ADDENDUM No. 1

TROY TAP PROJECT

Federal Project No. TAP-9900 (383)

CITY OF TROY, MISSOURI

Sheet 4:

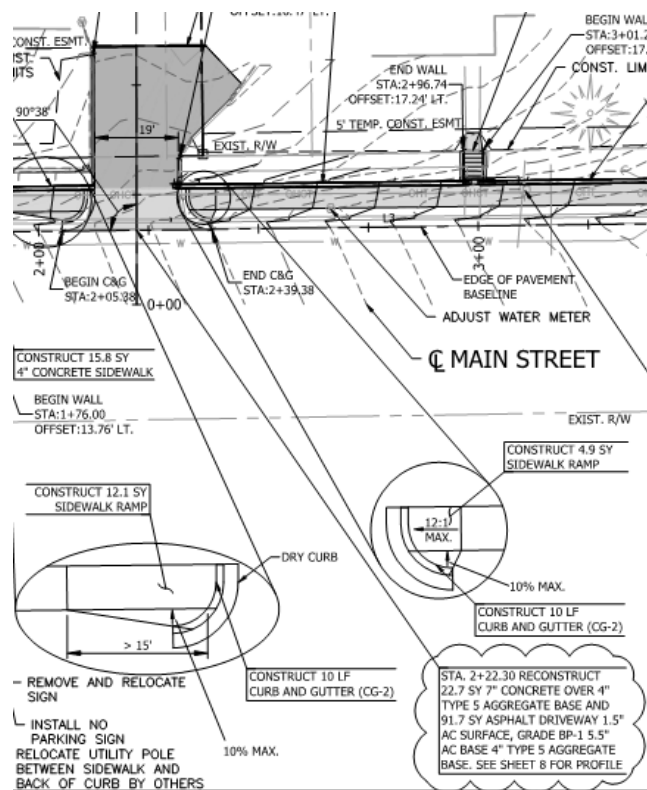
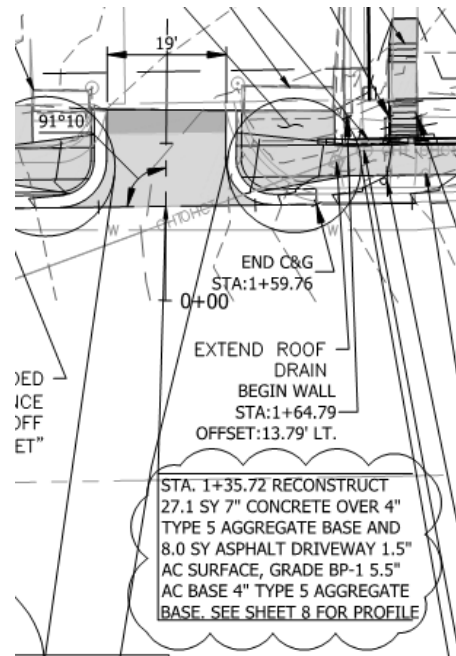
The commercial drive approaches have change from asphalt pavement to concrete pavement from the edge of Main Street to beyond the limits of the pedestrian route. The pavement shall remain as asphalt beyond the back side of the pedestrian walk way to the tie in location of the driveway.

Sheet 5:

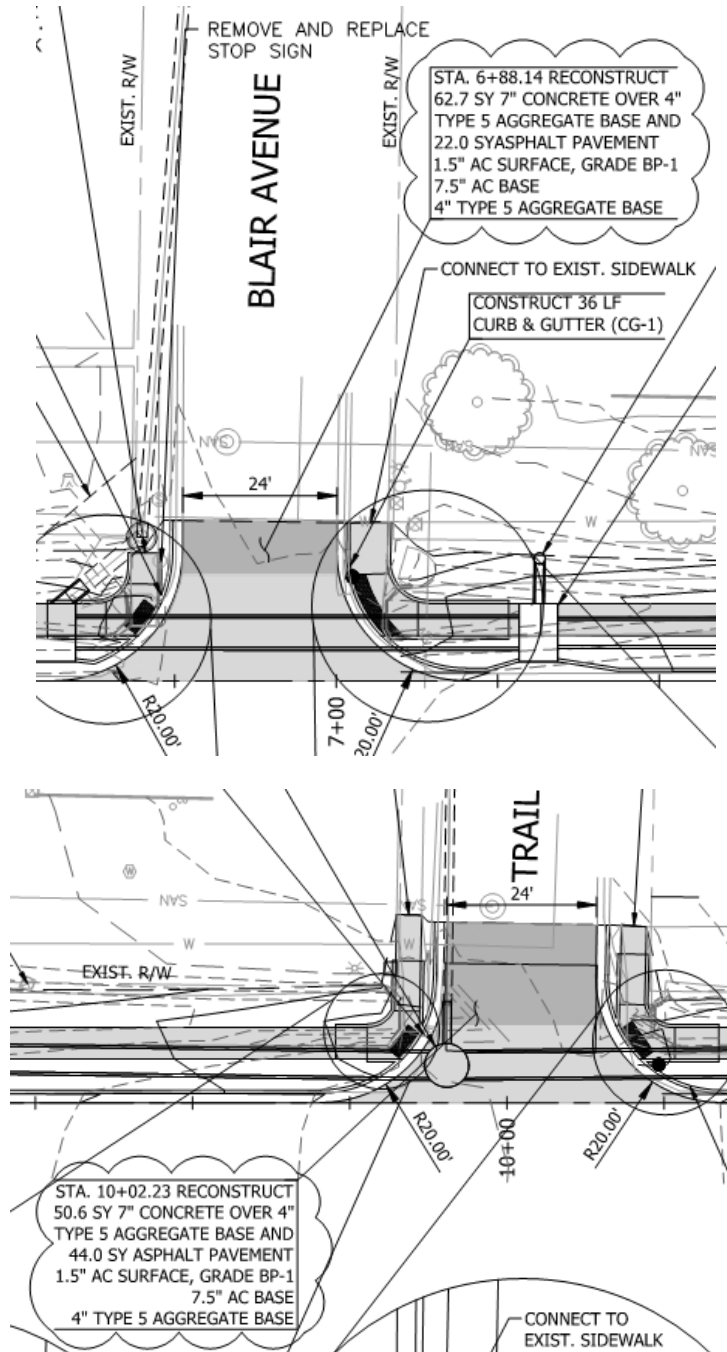
The side streets have changed from asphalt pavement to concrete pavement from the edge of Main Street to beyond the limits of the pedestrian route. The pavement shall remain as asphalt beyond the back side of the pedestrian walk way to the tie in location of the Blair and Trail Avenues.
